2165 JANITELL ROAD

SITE DEVELOPMENT POND PLAN / DETAILS

C1.3

PCD FILE NO. PPR2417

BLOCK WALL OVERFLOW SPILLWAY

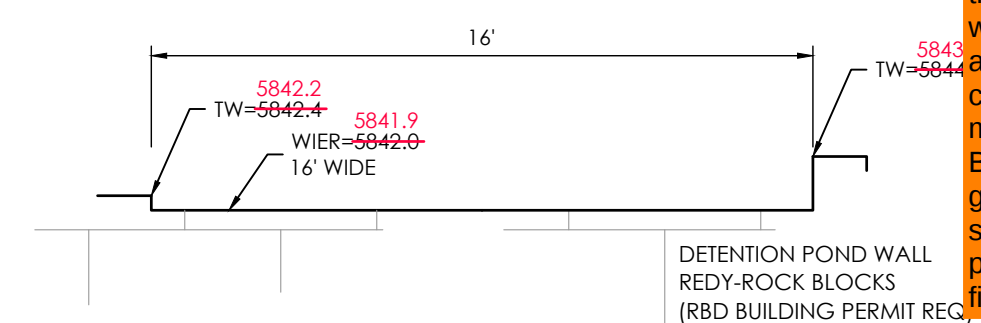
This transition is not what was actually observed in the field by EPC staff. The finished grade of the asphalt milling is actually several inches below the top of the blocks. There is potential the flows will concentrate along this defacto curb and flow to the lowest point which could be the southwest side of the site, meaning the runoff will bypass the pond. But regardless of where the flows end up going, the original design was for flows to sheetflow over the walls and into the pond, not be a concentrated flow that finds the path of least resistance.
